Re: **Ash Street Water Main Replacement (PR#67-2018)**  
**City of Cannon Beach (PWS ID#00164)**  
**Conditional Approval**

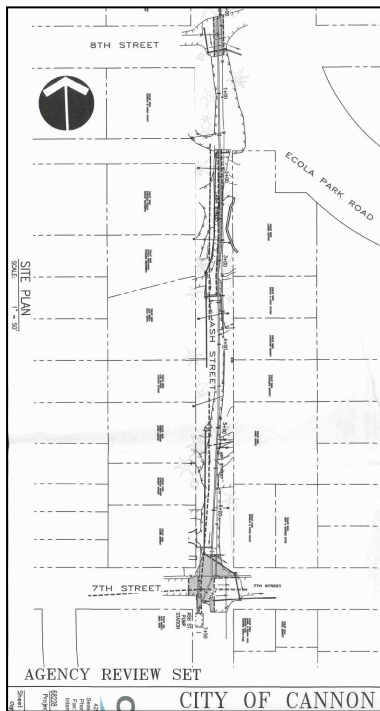
1. The design must allow for 20 psi to be maintained at the service meters.
2. Sewer crossings in which less than 18" of vertical separation between the bottom of the waterline and the top of the sewer pipe conform to OAR 333-061-0050(9)(c) as shown on the following page.

- (c) In situations where a water line and a sewer main or sewer lateral cross, the separation between the two shall be as follows:

- (A) Wherever possible, the bottom of the water line shall be 1.5 feet or more above the top of the sewer line and one full length of the water line shall be centered at the crossing;

- (B) Where the water line crosses over the sewer line but with a clearance of less than 1.5 feet, the sewer line shall be exposed to the sewer line joints on both sides of the crossing to permit examination of the sewer pipe. If the sewer pipe is in good condition and there is no evidence of leakage from the sewer line, the 1.5-foot separation may be reduced. However, in this situation, the water supplier must center one length of the water line at the crossing and must prepare a written report of the findings and indicating the reasons for reducing the separation. If the water supplier determines that the conditions are not favorable or finds evidence of leakage from the sewer line, the sewer line shall be replaced with a full length of pipe centered at the crossing point, of PVC pressure pipe (ASTM D-2241, SDR 32.5), high-density PE pipe (Drisco pipe 1000), ductile-iron Class 50 (AWWA C-51), or other acceptable pipe; or the sewer shall be encased in a reinforced concrete jacket for a distance of 10 feet on both sides of the crossing.
